Access Compliance Report

Public Rights-of-Way

(Curb Ramps)

Intersection ID: 9273	Main Street: KIRKDALE_CT	Cross Street: SLOAN_DR	Location:	N
ADA ID: C3997C029A64	Ramp Type: Perp	Initial Pass/Fail: Fail	Overall Compliance: No	Severity Score: 17.5

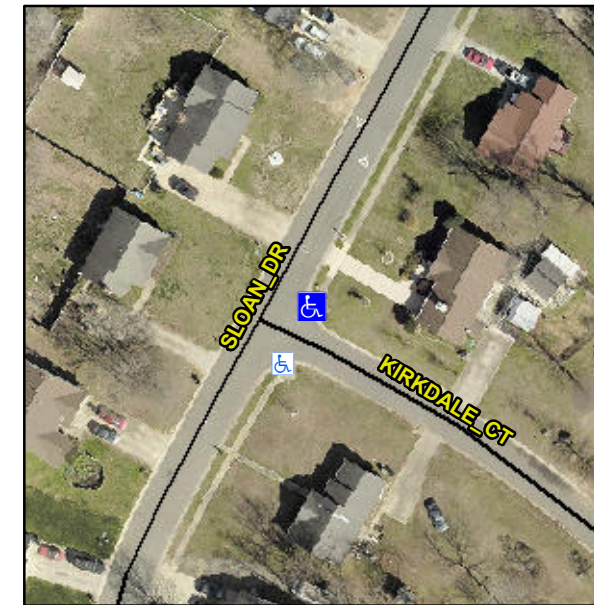
R304.5.1

Compliance	Description	Data	Compliance	Description	Data
N/A	Ramp Length (in)	46.0	Yes	Ramp Slope (%)	7.5
No	Ramp Width (in)	34.0	Yes	Ramp XSlope (%)	0.4
N/A	Flare Type LT	N/A	N/A	Flare Type RT	N/A
N/A	Flare Slope LT (%)	N/A	N/A	Flare Slope RT (%)	N/A
N/A	Flare Traversable LT?	N/A	N/A	Flare Traversable RT?	N/A
N/A	Landing Length (in)	N/A	N/A	DWS Provided?	N/A
N/A	Landing Width (in)	N/A	N/A	DWS Contrast?	N/A
N/A	Landing Slope (%)	N/A	N/A	DWS Length (in)	N/A
N/A	Landing X Slope (%)	N/A	N/A	DWS Full Width?	N/A
N/A	Landing Curb? (Y/N)	N/A	N/A	DWS Offset (in)	N/A
N/A	Shared Landing?	N/A			
N/A	Gutter Ponding?	N/A	N/A	Gutter Slope (%)	N/A
N/A	Gutter Lip Ht (in)	N/A	N/A	Gutter X Slope (%)	N/A
N/A	Painted X Walk1?	No	N/A	Painted X Walk2?	N/A
	X Walk 1 Direction	To SW		X Walk 2 Direction	N/A
N/A	X Walk 1 Width (in)	N/A	N/A	X Walk 2 Width (in)	N/A
	X Walk 1 Slope (%)	0.4		X Walk 2 Slope (%)	N/A
	X Walk 1 X Slope (%)	2.6		X Walk 2 X Slope (%)	N/A

Remove & Replace Entire Ramp.
